IN THE DRAWINGS

REMARKS

In response to the Office Action mailed October 18, 2002, Applicants respectfully request reconsideration.

FIG. 7

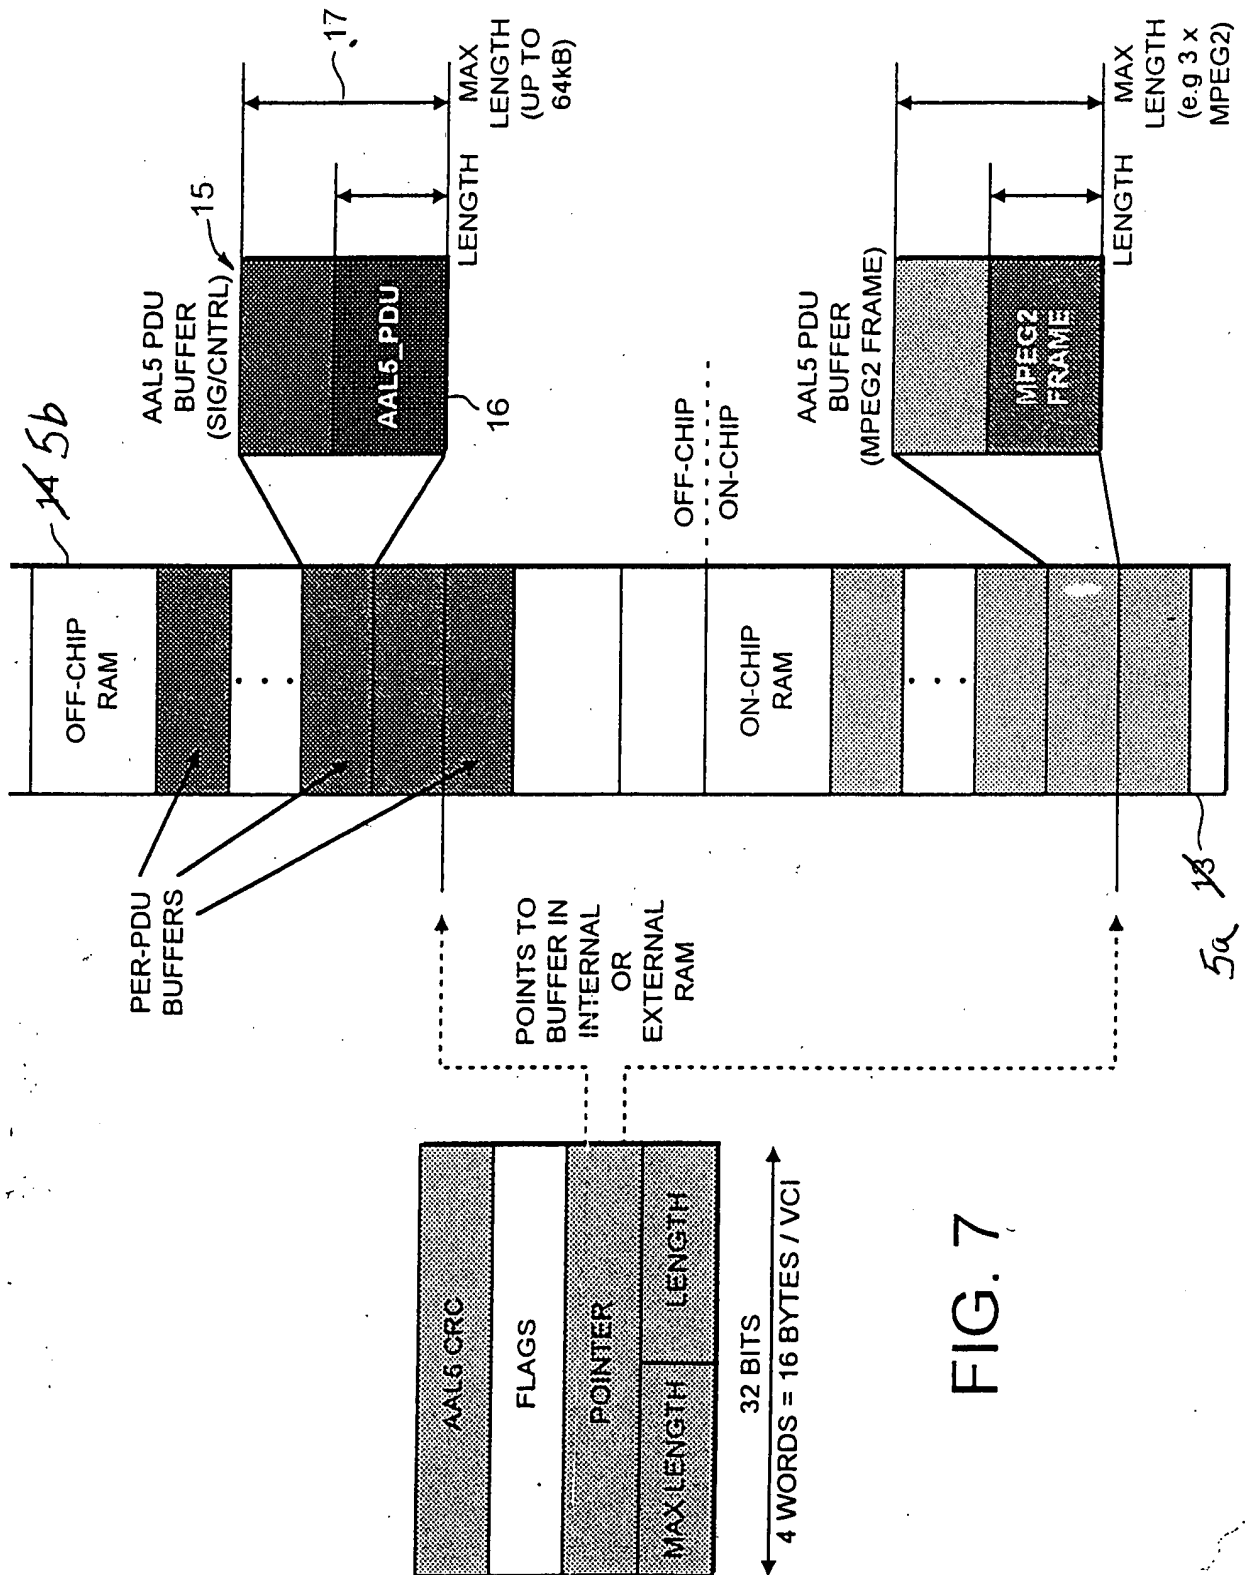
The Examiner's approval is respectfully requested for the proposed change to Figs. 7 and 12 of the drawings shown in red ink in the copy attached to the accompanying Request for Approval and Entry of Formal Drawings.

In paragraph 2, Fig. 12 was objected to because it did not include reference designator 44 as described at page 17, line 11 in Applicants' specification. Fig. 7 was objected to because reference numerals 13 and 14 shown therein were not described in Applicants' specification. Fig. 12 has been amended to add reference designator 44. Support for this amendment is provided at page 17, lines 11-13 of Applicants' specification as originally filed. Fig. 7 has been amended to replace reference designators 13 and 14 with reference designators 5A and 5B. Support for this change is provided at page 13, third full paragraph, of Applicants' specification
